Bulletin#: TB2020-01

Technical Bulletin Regarding ASME Code (Individual PRV Elimination)

Applicable Models: iQ751, iQ1001, iQ1501

Upgraded Manifold

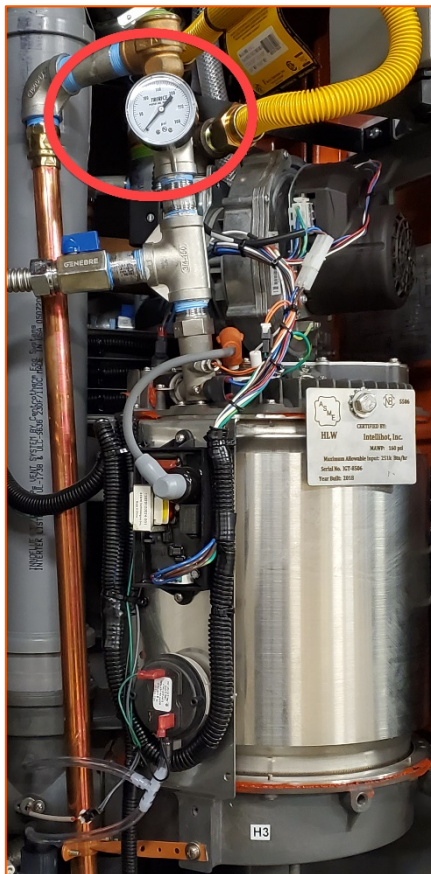
- Fewer components/connections on the waterside to have potential leak issues.
- ASME certified as one unit, so only one ASME inspection required (save cost).
- Manifolds upgraded and certified (see Image below).

HEX with PRV (old)

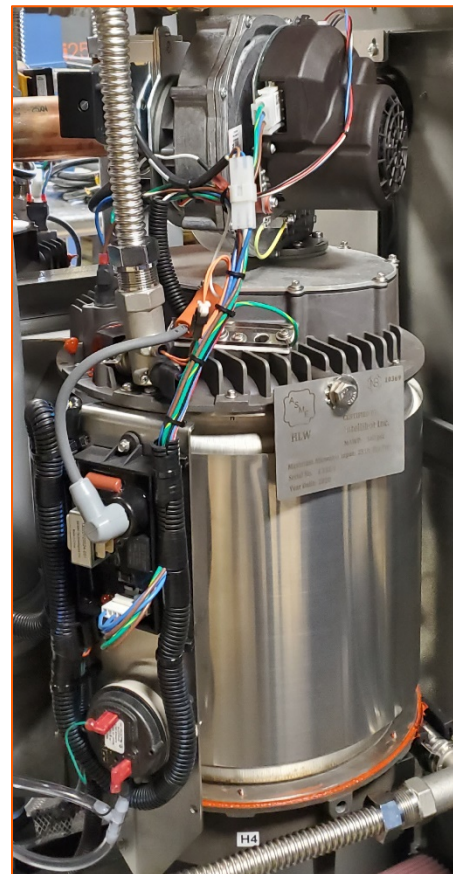
- A pressure relief valve (PRV)
- Stop valves on the outlet piping
- Bottom drain
- Thermometer and pressure gauge at the outlet
- Manifold is upgraded quality and ASME certified.

These components are no longer required for the units and thus will be removed from production starting with units shipped:

HEX without PRV (new)
